**TRANSMITTAL OF RESPONSES TO THE OHIO ENVIRONMENTAL PROTECTION AGENCY
COMMENTS ON THE DRAFT PROJECT SPECIFIC PLAN FOR SAMPLING OF
MISCELLANEOUS AREAS FOR THE ON-SITE DISPOSAL FACILITY WASTE ACCEPTANCE
CRITERIA ATTAINMENT**

RESPONSES TO OHIO ENVIRONMENTAL PROTECTION AGENCY COMMENTS
ON THE PROJECT SPECIFIC PLAN FOR SAMPLING OF MISCELLANEOUS AREAS
FOR ON-SITE DISPOSAL FACILITY WAC
(20600-PSP-0001, REVISION 0)

V/FCN 20600PSP1-3

FIGURE 1. V/FCN 20600-PSP-0001-3

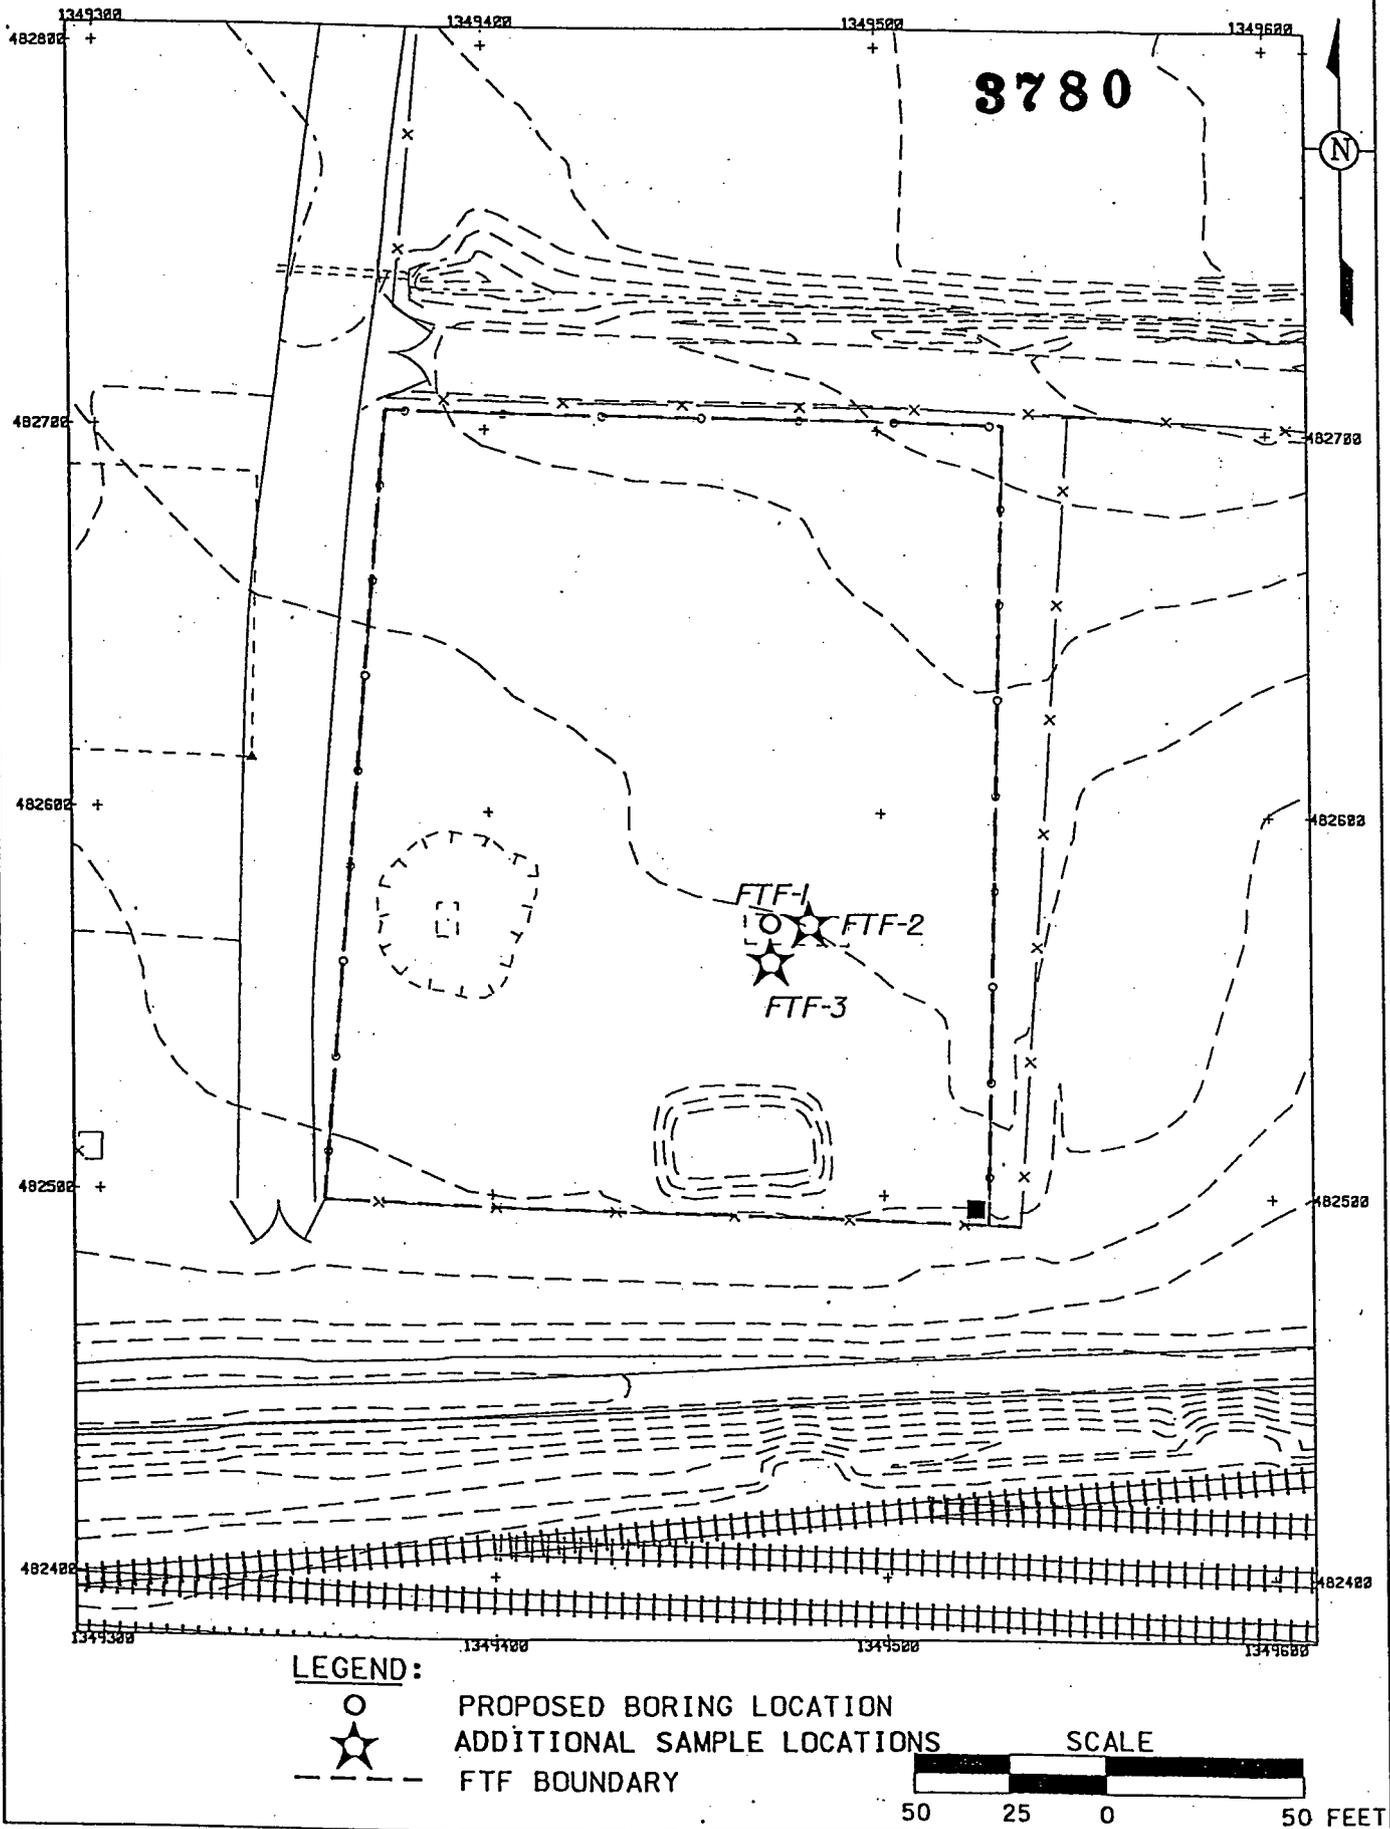
Comment: This table lists the depth for the sample of 4-Nitroaniline in the Former Fire Training Facility as 'surface'. After reviewing the May 1995 Final Report on the Contamination at the Fire Training Facility Removal Action No. 28, it would appear that backfilling, to the maximum depth of 2 feet, occurred in the area of this sample. Therefore, sampling must occur at the top of the native soils, not in the surface. Please correct.

This Variance/Field Change Notice (V/FCN) documents additional sample intervals at sample location FTF-1 and two additional sample locations. The two additional sample locations are approximately 10 feet from FTF-1 and are shown on Figure 1. All three FTF locations will be advanced to a depth of 5 feet and sample intervals will be collected at 0.0'-0.5', 2.0'-2.5', 3.0'-3.5', and 4.5'-5.0'.

Response: Agree. After reviewing RA 28, it appears that backfilling occurred at 2 feet lifts. It also appears that two lifts were conducted. Therefore, the sample location will be collected to a depth of 5 feet and three 6-inch sample intervals will be collected and two additional locations will be collected nearby.

After reviewing Removal Action 28 it was determined the area was backfilled during excavation in two foot lifts. Due to the backfilling during excavation multiple sample intervals are being collected. In response to OEPA's comments, two additional samples have been placed near the historical location to provide additional supporting data.
